Amendments to the Drawings

Appl. No. 10/808,407 Amdt. Dated June 9, 2006 Reply to Notice of Non-Compliant Amendment of May 30, 2006 Attorney Docket: QSTR-102

FIG. 6

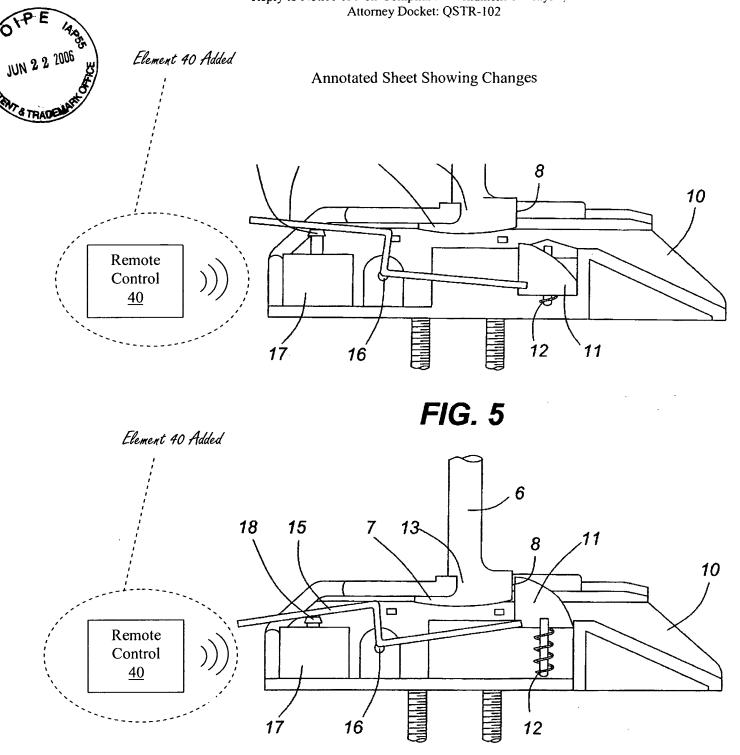
The attached sheet of drawings includes changes to Figures 5 and 6. This sheet, which

includes Figures 5 and 6, replaces the original sheet including Figures 5 and 6. In both Figures 5

and 6, a labeled rectangular box is added and identified as reference number 40 to represent the

remote control as described on page 6 lines 9-12 of the description.

First, the Examiner objects to the drawings under 37 CFR 1.83(a) for failure to show the

remote control of claims 35 and 38. 37 CFR 1.83(a) requires that drawings in nonprovisional

(e.g., a labeled rectangular box)." The Applicant respectfully asserts that the claimed remote

control is a conventional feature which is disclosed in the description on page 6, lines 9-12:

hereby amends the drawings to illustrate the remote control in the form of a labeled

representation, in accordance with 37 CFR 1.83(a). The applicant also amends the description
